**NOTICE OF A PUBLIC HEARING BEFORE
THE CITY COUNCIL ON AN APPEAL OF THE
PORTLAND LAND USE HEARINGS OFFICER**

CASE FILE: LU 11-153362 LDS ENM
WHEN: WEDNESDAY, OCTOBER 10, 2012 @ 2:00 PM
WHERE: COUNCIL CHAMBERS, 1221 SW FOURTH AVENUE

File No. LU 11-153362 LDS ENM (HO 4120015)

Re: Appeal Additional Evidentiary Response

Figure 1
Enlarged View of proposed lot layout at
SE Berkeley Way.

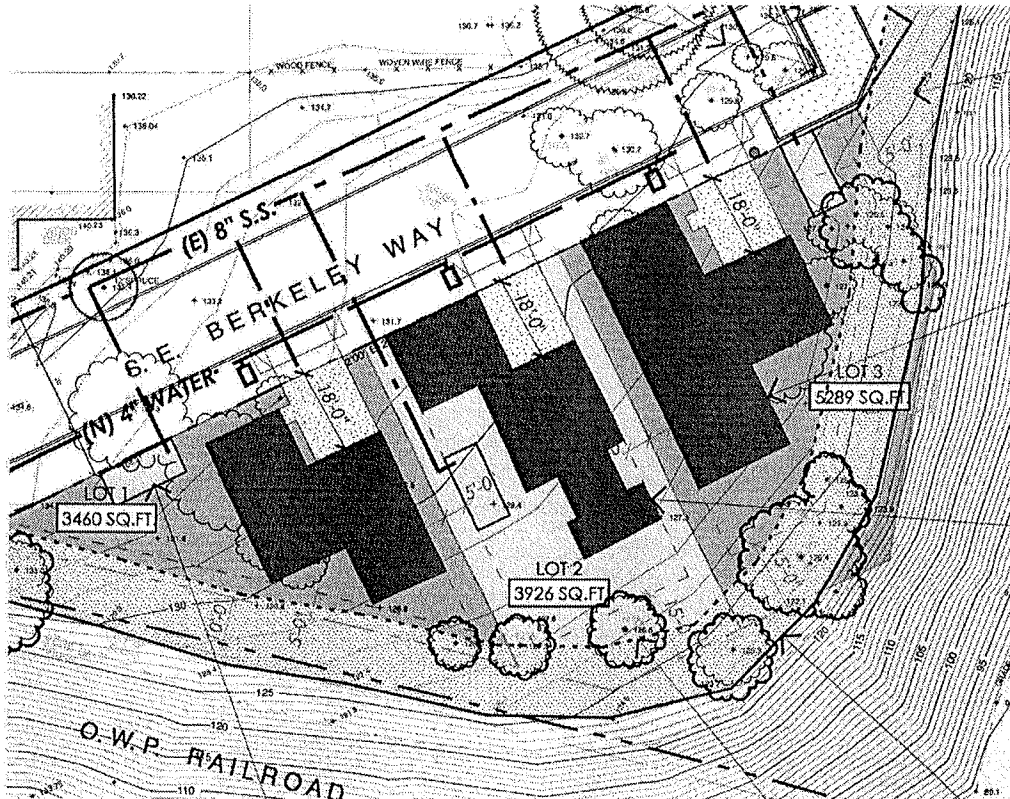
"PCC33.641 requires the applicant to provide evidence in the record sufficient to demonstrate that the identified evaluation factors are satisfied. One of the evaluation factors requires the applicant to review on-street parking impacts of the proposed development. The hearing officer found that the applicant failed to provide adequate evidence in the record."

On-site parking is accommodated on each of the proposed lots. (Lot 4 fronting on SE Tenino is not affected, as it does not abut the SE Berkeley Way Right of way.) A minimum of two on-site parking spaces can be accommodated with a typical 18-foot setback and a 16-foot wide driveway for the lots abutting SE Berkeley Way. Up to four parking spaces could be accommodated on each site should a two-car garage be developed in conjunction with the aforementioned driveway. (See figure 1)

This allows up to four (4) on site parking spaces limiting the on-street parking impact.

The proposed 20-foot wide street improvement requires that there be no on street parking due to emergency vehicle access on a dead end street. On street parking, when required and not accommodated by on-site parking, would then be forced out onto SE Caesar Chavez Blvd.

FIG. 3

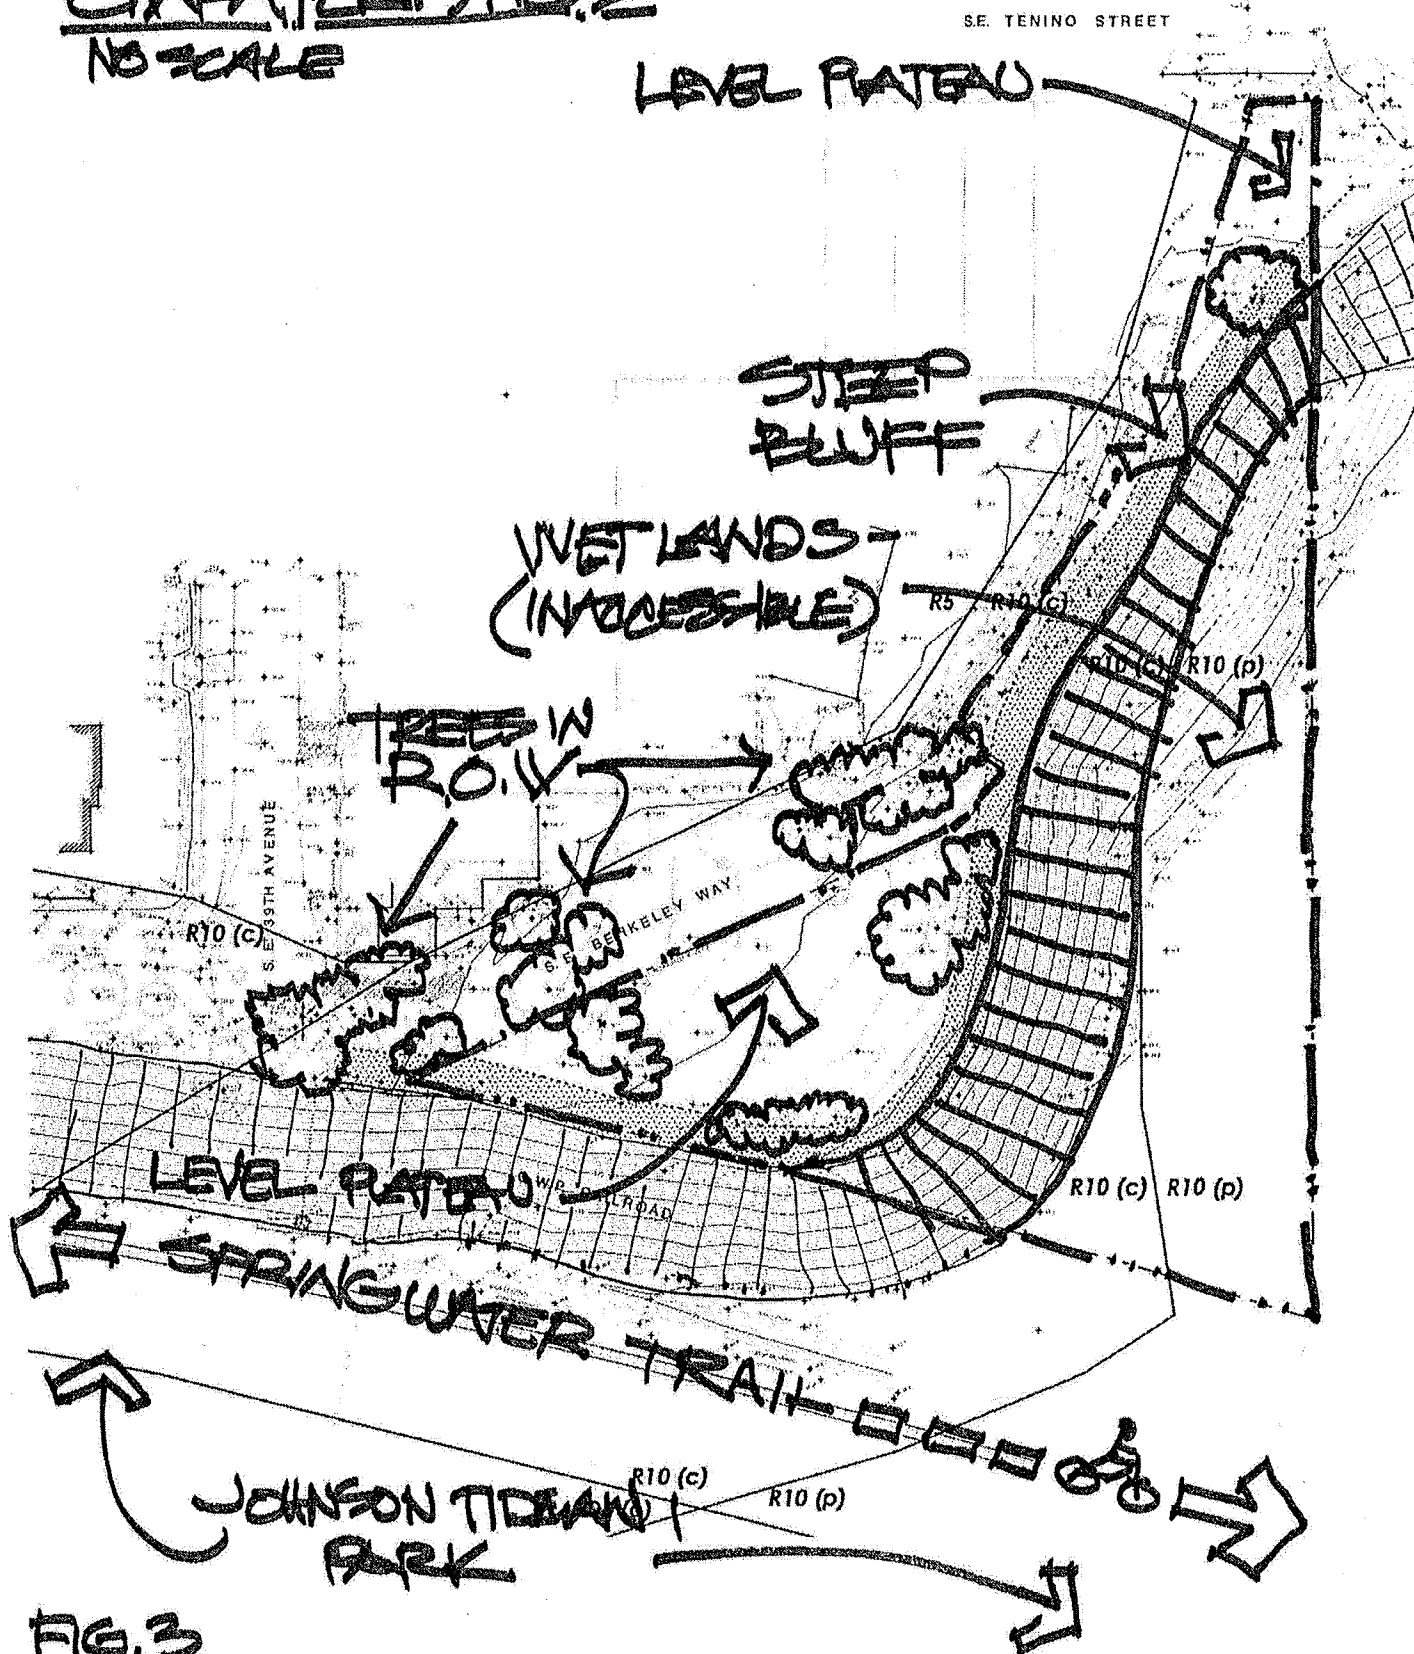
"PCC 33.430.250 A.1, A.3 and A.4 require an applicant to conduct an environmental alternatives analysis related to locations, designs and construction methods. The alternatives analysis must consider whether or not proposed alternatives are practicable and then determine which of the practicable alternatives creates the least significant detrimental impacts upon identified environmental resources and functional values. The Hearings Officer found that the applicants submissions failed to provide substantial evidence to satisfy the PCC 33.430.250 A.1, A.3 and A.4 approval criteria."

Attached is a **General Site Characteristics** (figure 3) diagram identifying the important site characteristics and four (4) alternative proposals for a land division. Each alternate requires street improvements within the SE Berkeley Way unimproved right of way (ROW) and places lots away from identified resources of the protected zone wetlands and flood plain, Johnson Tideman Park, the Springwater Corridor bikeway and the bluff overlooking all of the resources.
